## Proposal for Supplement 8 to the 00 series of amendments, Supplement 5 to the 01 series of amendments, Supplement 4 to the 02 series of amendments and Supplement 1 to the 03 series of amendments to UN Regulation No. 129

Submitted by the expert from the European Association of Automotive Suppliers

Paragraph 4.5., amend to read:

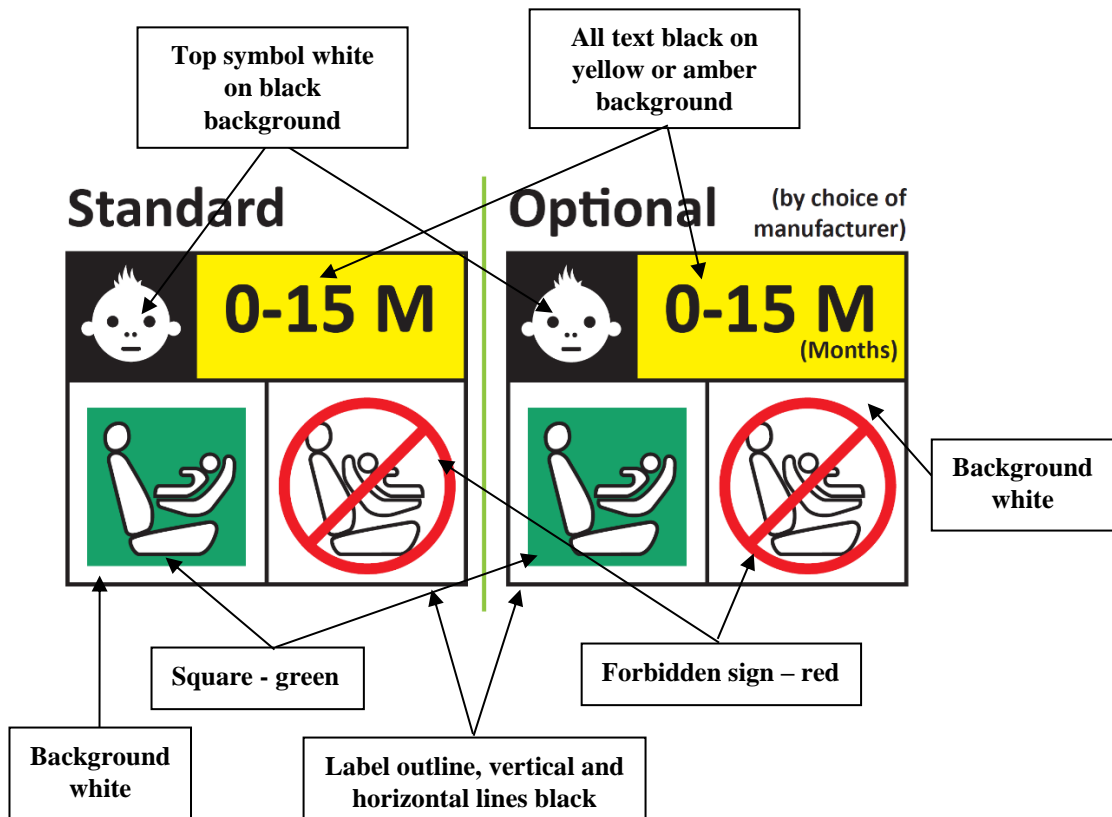
1. Paragraph 4.5. specifies labels that emphasise that the ECRS should not be used by children under 15 months. For consistency reasons, the same layout is chosen for both, the rearward/forward facing and the forward facing only label.
2. This proposal adapts the pictogram of the white face on the black background which is placed next to the age range. The face is adapted from a smiling face to a neutral face to handle the conflict between a smiling face and a forbidden sign below.
